Access Compliance Report Public Rights-of-Way (Pedestrian Signals)

Main Street: GILBERT_ST Cross Street: CERRITOS_AVE Location: NE

ADA ID: SGRK210923130714 Signal Type: One Push Button-Non APS Overall Compliance: No Severity Scores: BTN 1: 25 BTN 2: N/A No BTN: N/A

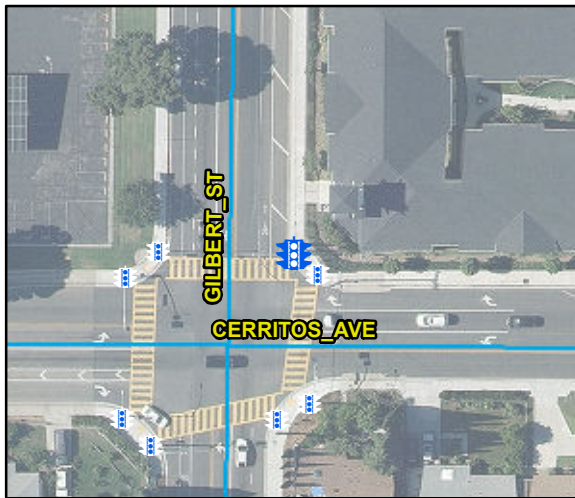
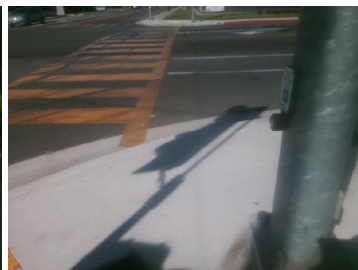
Yes B 1 Closed Fist Operation?		Yes	N/A	B 2 Closed Fist Operation?	N/A
Yes B 1 Diameter (in)		2	N/A	B 2 Diameter (in)	N/A
N/A B 1 Crossing Direction		W	N/A	B 2 Crossing Direction	N/A
Yes B 1 DistanceTo XWalk (in)		45	N/A	B 2 DistanceTo XWalk (in)	N/A
No B 1 DistanceTo Curb (in)		80	N/A	B 2 DistanceTo Curb (in)	N/A
Parcel Identification Number		127-401-39			
Google Street View Link

Possible Solutions: Replace Signal Push Button With APS Button. Remove & Relocate Sign.

OC Std/PROW: MUTCD 4e.08, R404.2
